ZONING

REQUEST: Approval of a change in zoning to single family residential to allow for development of a residential subdivision

A request to create a new Planned Development to allow for the development of a single-family residential subdivision.

11-15Z2 Singer Ranch (zoning)

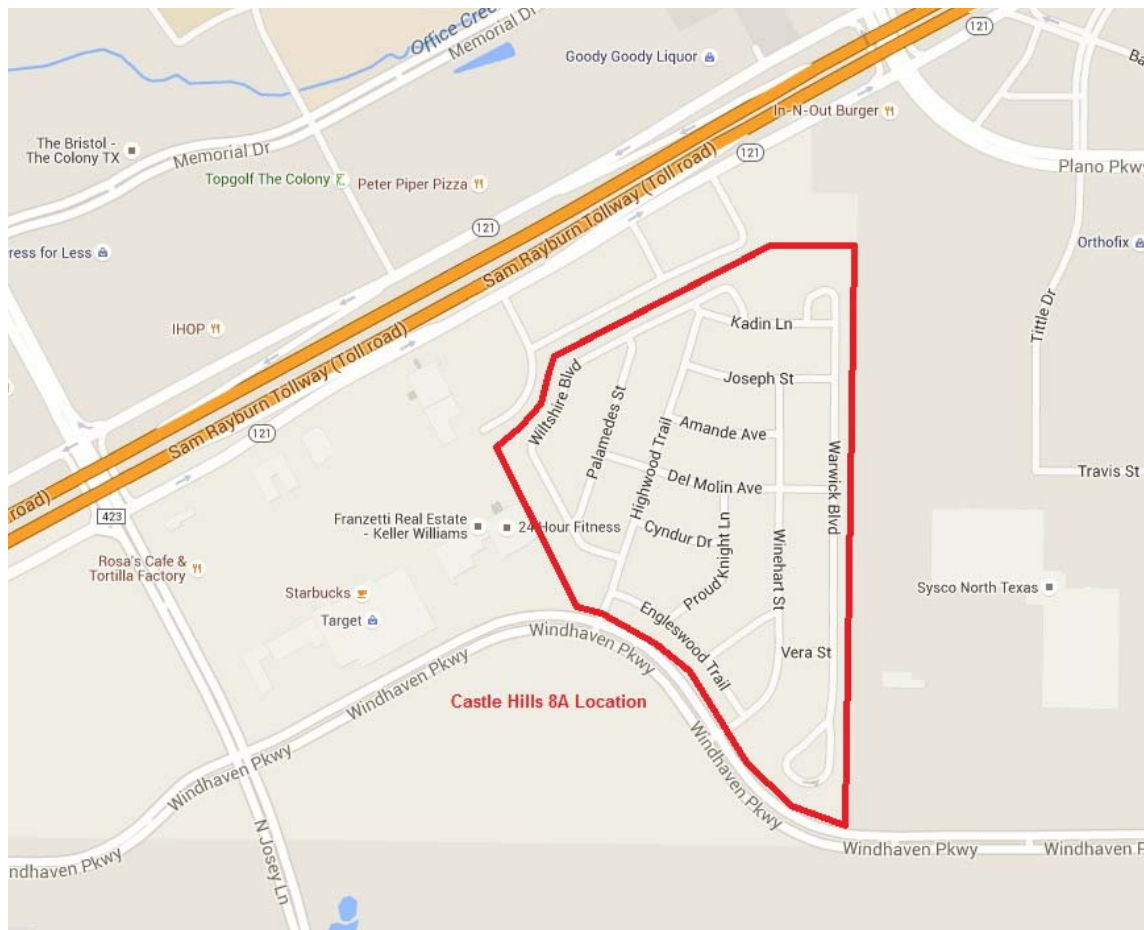
1. Of the total 94.4-acre tract, about 19 acres (20%) is encumbered by a flood plain and may not be developable. An additional approximately 12 (13%) acres is encumbered by a high-tension power transmission line easement or “cut off” from the bulk of the property by this easement and cannot be developed. Thus, about a third of the total property is undevelopable.

2. The exact amount of land in the flood plain which cannot be developed is unknown, because a complete engineering study has not been completed. The lots along the south side of (extended) Indian Run Drive (which may have another name in this subdivision) have purposely been designed with extra depth to allow for some change.

3. The existing pond near the north central portion of the site would be drained, filled and graded to provide for additional developable lots.
4. The proposed subdivision would be a part of the Castle Hills Homeowners Association, which is responsible for several maintenance items (such as annual trimming of street trees) and services (such as door-to-door mail delivery) which exceed the functions of any HOA in Carrollton. An HOA “write up” provided by the applicant is included later in this case report.

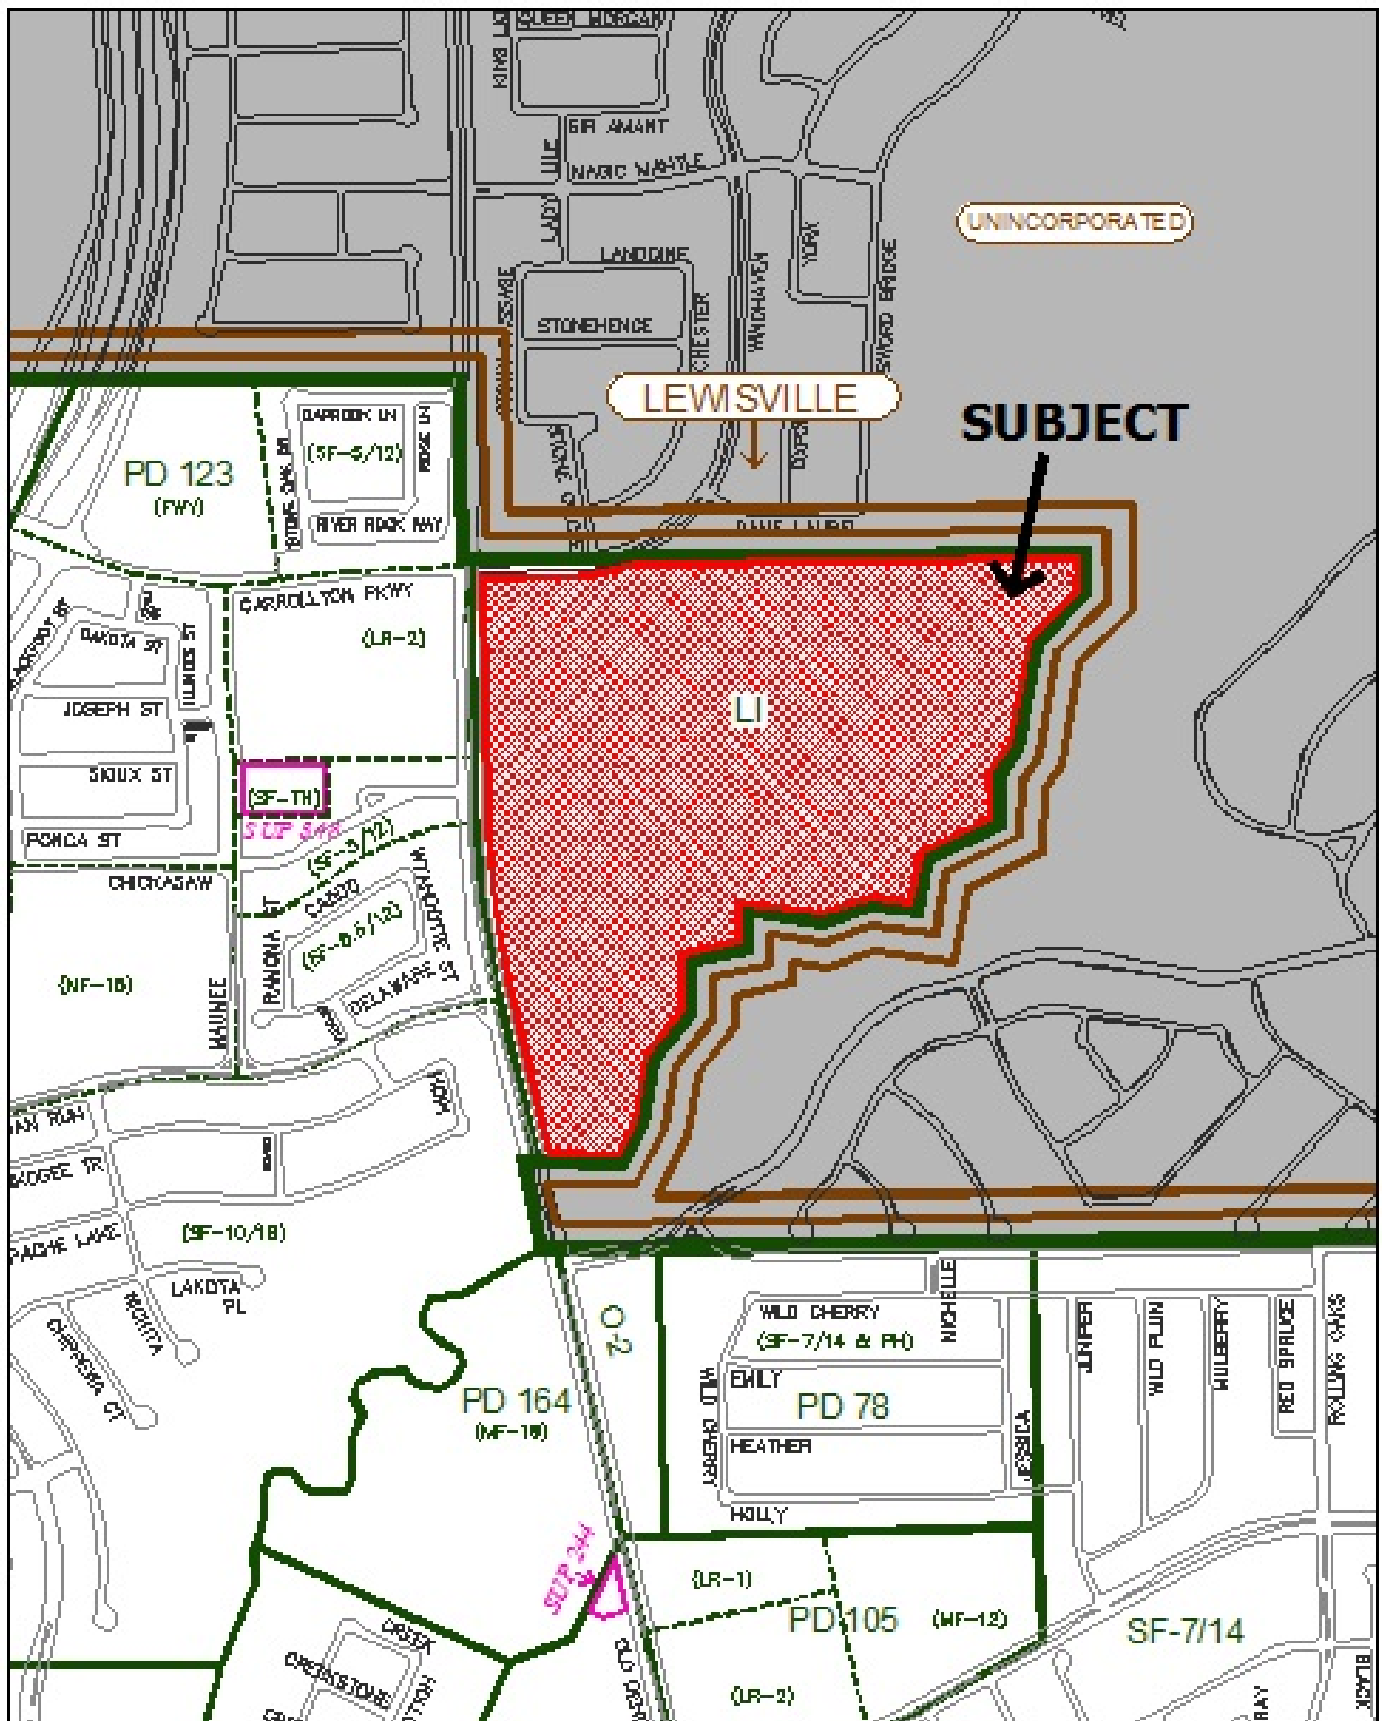
Because this dedication will shift the westerly lot line of several lots to the east, the applicant is asking for reduced front and rear yard setbacks for those affected lots. On the current preliminary plat these lots are labeled as Lots 31, 33 and possibly 34. Approval of this request will remove the need for the applicant to redesign this portion of the subdivision, with the exception of the proposed right-of-way dedication.

- B. During the design of the preliminary plat, the applicant determined that several lots appeared too small to for the houses they were planning. After further investigation and discussion with staff, the number so affected were determined to be two: Lot 33, Block A (backing up to Old Denton Road near the northwest corner of the subdivision) and Lot 8, Block E, (on a street “elbow” about a block away from the first lot, more internal to the subdivision. See the image below showing the general location of these lots.

The applicant is requesting a further reduction in front yard setbacks (beyond what they are requesting for the subdivision as a whole) as follows:

Lot 33, Block A: additional two-foot reduction, such that the house will be 9 feet, and the garage door will be 18 feet from the front property line

Lot 8, Block E: an additional four-foot reduction in the front yard setback for the garage only, such that the house will remain at 11 feet from the property line, and the garage will be 16 feet from the property line.
